Customer Service Bulletin
Commercial Business Group

Workman® Topdresser 1800

Model/Serial Range:	Model Number:	Serial Numbers:
	44220	30001-50400

Subject: Lift Cylinder does not align with mounting hole.

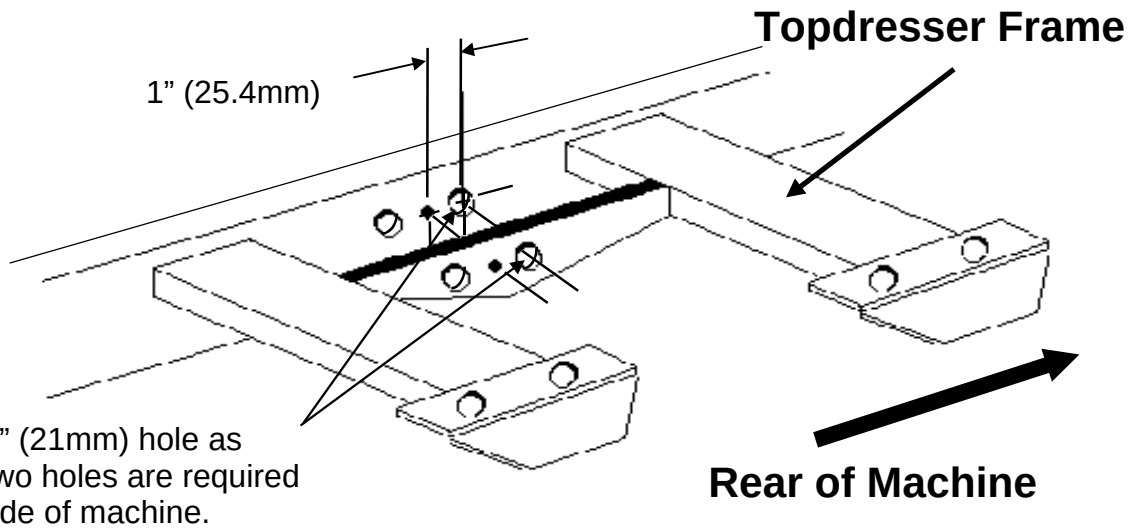
The Lift Cylinder is 1 inch (25mm) longer on Workman Traction Units beginning with Serial Number 60001 to provide an improved lifting height in flatbed accessory applications. Due to this change, the lift cylinder will not connect properly to the frame of a Topdresser with a serial number in the range listed on this bulletin.

In instances where the Topdresser 1800 is only installed to the Workman for short period of service then removed, it may be unnecessary/unimportant to connect the lift cylinders to the Topdresser. However, the frame of the Topdresser may be modified by adding new mounting hole locations, if connection of the cylinders is desirable.

Locate new hole 1” (25.4mm) from small hole in mounting frame.

Add 13/16” (21mm) hole as shown. Two holes are required on each side of machine.
